STAFF REPORT

Site Plan Review (Type III)

SITE LOCATION: 3333 Ocean Boulevard, Coos Bay, Oregon
25 S 13 W 21 C Tax Lots 501 & 700

CASE FILE/SUBJECT: **#187-ZON17-055 Site Plan Review (SPR) for improvements to the south side bleacher area of Marshfield High School's Susick Stadium including: the installation of permanent seating, a roof cover over the spectator and bleachers area, a new press box, restrooms, a memorial plaza, and enhanced access for ADA mobility in the Urban Public district.**

Attachment B

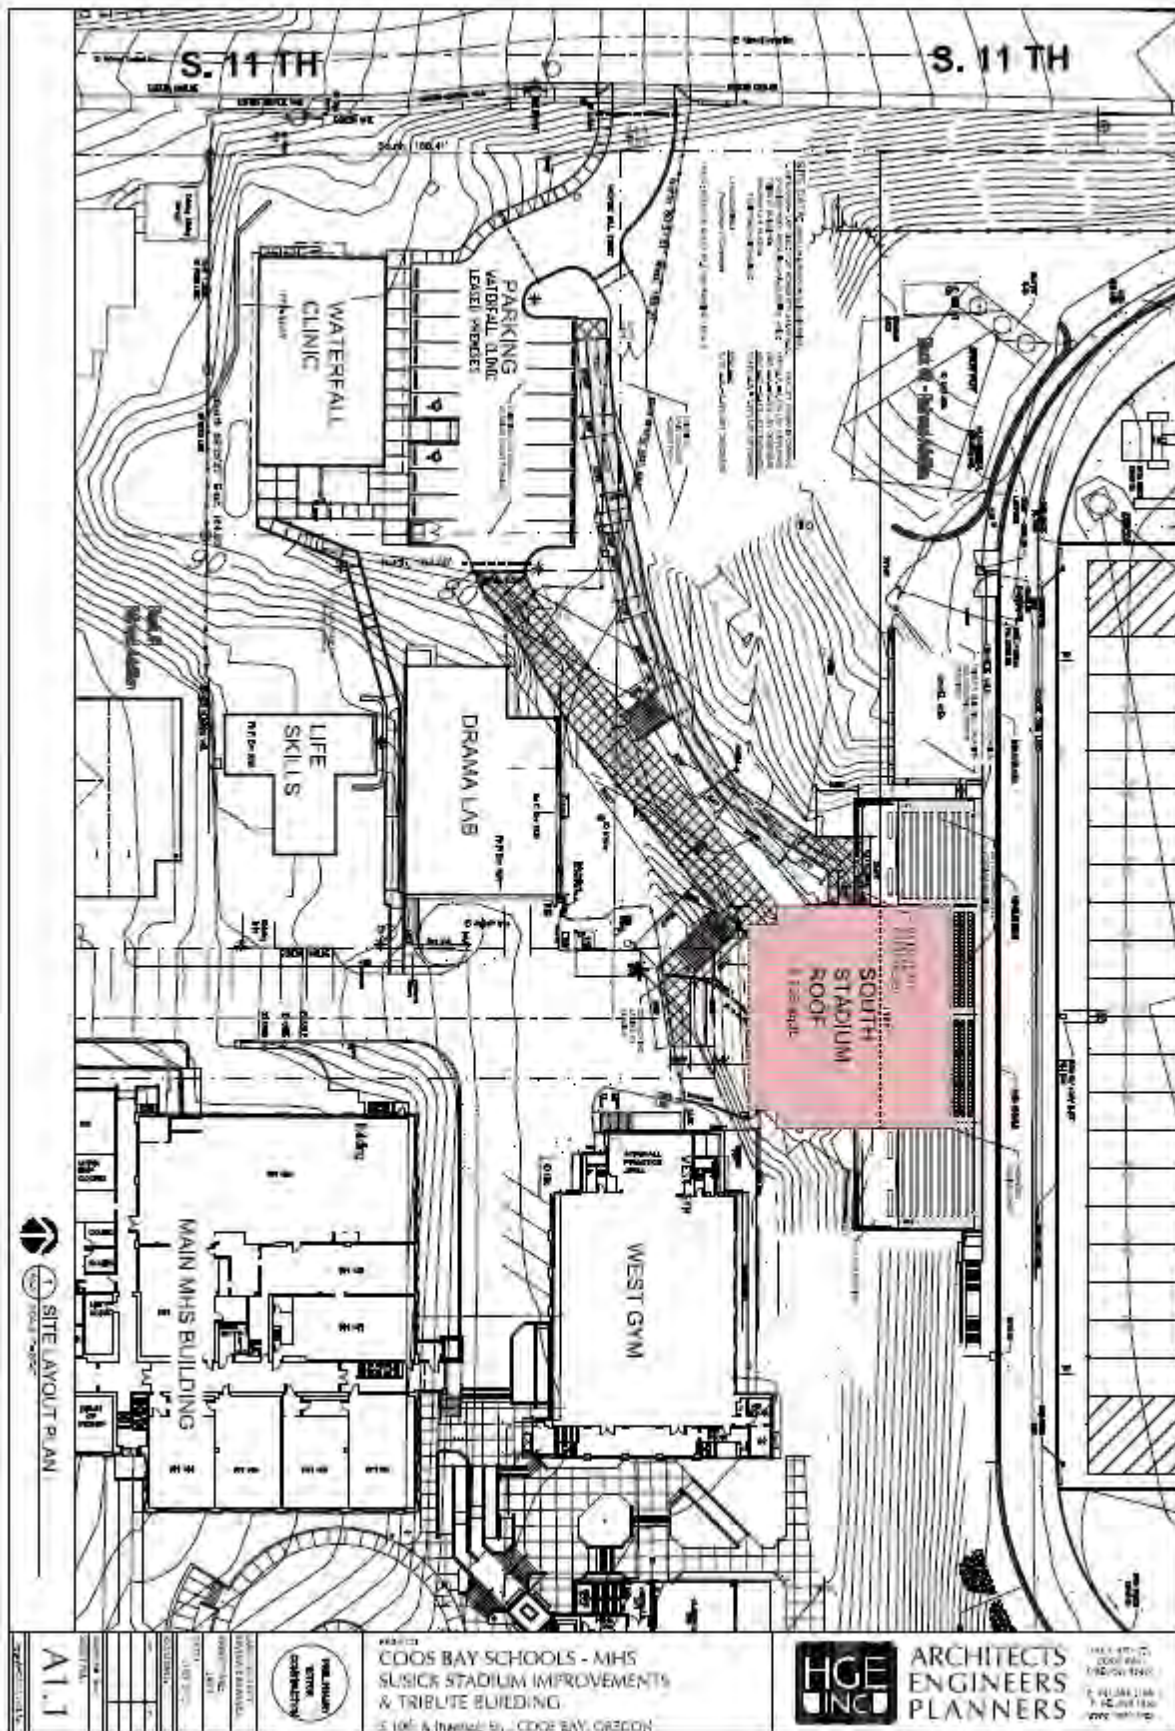
As proposed and based on both the site plan and the elevations being reviewed, the proposed improvements will satisfy all dimensional requirements of the UP district which includes lot area, building setbacks, lot coverage, and building height. Although the furthest reaches of a portion of the new roof structure may exceed the 35-foot height limitation, the tallest support structure for the roof is illustrated as being 32 feet which is determined to comply with this dimensional requirement.

“Proposed Plaza Walkway and ADA ramp along with corresponding improvements are considered to be permanent structures. Per the design and submitted plans it appears that the locations of these structures may be crossing public and private infrastructure consisting of a 10” sanitary sewer main, a 12” storm sewer main, and unidentified storm sewer line(s) originating at the north side of the parking lot of the Waterfall Clinic. The City does not allow permanent structures to be placed over public sewer (storm or sanitary) systems.

The application only shows one pipe from the north parking lot that serves the Waterfall Clinic to manhole 34AD-9s. However, the City has information that was submitted with the Waterfall Clinic that proposed to construct another pipe from said parking lot to just upstream of manhole 34AD-9s. As a result, with this option, there are potentially two storm drain pipes that extend from the north parking lot that shall be replaced (Approximately 180').

- A. Privatization of these assets to become the responsibility of the Coos Bay School District to maintain the integrity of this pipeline prior to and thereafter as to avoid conflict.*
- B. Remove and replace the existing pipeline from manholes 34AD-10s to 34AD-9s (approximately 135') and relocation of the manhole on the 12" storm line located by the French drain on the north side of the proposed ADA ramp to remove it from the footprint of the structure. The manhole must be relocated at a minimum horizontal distance from the permanent structure in accordance with City standards, which is based on the depth of the manhole. The minimum horizontal distance from the structure with depths 5 feet or less is 7.5 feet. For each additional 5 feet of cover over 5 feet (rounded up), the horizontal distance will increase in 5 feet increments from the center of manhole.*

In regards to 10" sanitary sewer line this asset will remain a publicly maintained utility and the City is requiring that the pipeline be replaced with engineering approved piping and installation specifications from manholes 34AD-5 to 34AD-3 (approximately 175'). Additionally, relocate Manhole 34AD-4 from the proposed structure's foot print. The manhole must be relocated at a minimum horizontal distance from the permanent structure in accordance with City standards, which is based on the depth of the manhole. The minimum horizontal distance from the structure with depths 5 feet or less is 7.5 feet. For each additional 5 feet of cover over 5 feet (rounded up), the horizontal distance will increase in 5 feet increments from the center of manhole. (See exhibit)
